# APR1400 Design Certification Review I&C Topics

KEPCO/KHNP  
May 2-3, 2016

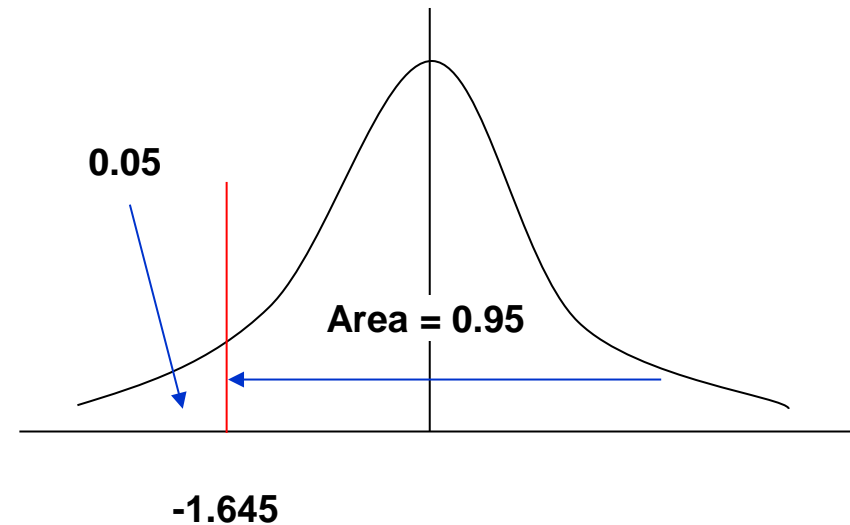
*It is not clear to the staff why these coefficients are consistent with the 95/95 tolerance limit discussion in Regulatory Guide 1.105, Rev. 3, which the staff interprets the limit to correspond to an error distribution approximately equal to two sigma value, 1.96, and not 1.645 as stated in the Technical Report APR1400-F-C-NR-14001. Provide justification and supporting analysis for this deviation from the guidance within RG 1.105.*

- Response to NRC Question

<Two-sided confidence interval>

$$\int_{-k\sigma}^{+k\sigma} g(x)dx = 0.95$$

<One-sided confidence interval>

$$\int_{-k\sigma}^{\infty} g(x)dx = 0.95$$
